**From:** ANDERSON, Victoria <vka@nei.org>  
**Sent:** Monday, December 10, 2018 9:23 AM  
**To:** Reisi Fard, Mehdi; Hartle, Brandon  
**Cc:** Rosenberg, Stacey; Casto, Greg; Vasavada, Shilp; Evans, Jonathan; Drouin, Mary; Weerakkody, Sunil; Linthicum, Roy R.:(GenCo-Nuc); KRUEGER, Greg; GEIER, Stephen  
**Subject:** [External\_Sender] RE: FYI- Execution of the subset of issues from the standard important to TSTF-505 & NEI-17-07  
**Attachments:** NEI 17-07 R1 Dec 2018.docx; Resolution of NRC comments on NEI 17-07.docx

A revision of NEI 17-07 is attached, as is a comment resolution table. We look forward to discussing on 12/17.

PERFORMANCE OF PRA PEER REVIEWS USING THE ASME/ANS PRA STANDARD

**Figure 1-1: Peer Review Process**

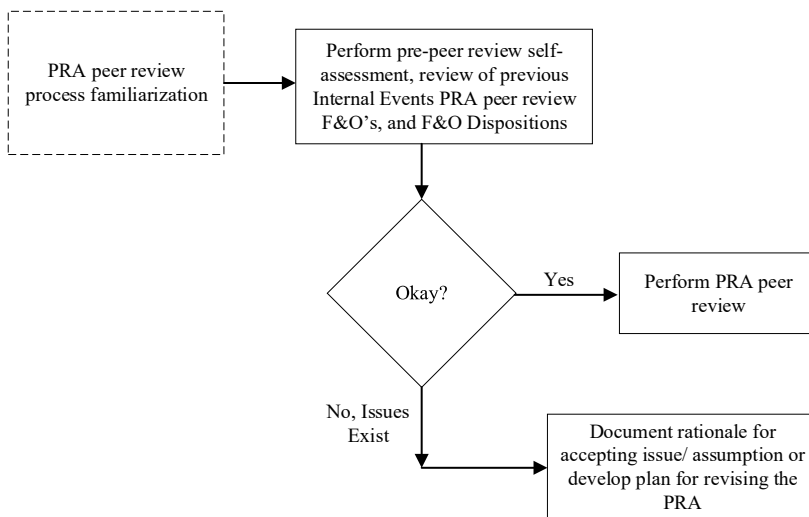
**Commented [NRC28]:** When issues exist, who is performing the documentation or developing the plan?
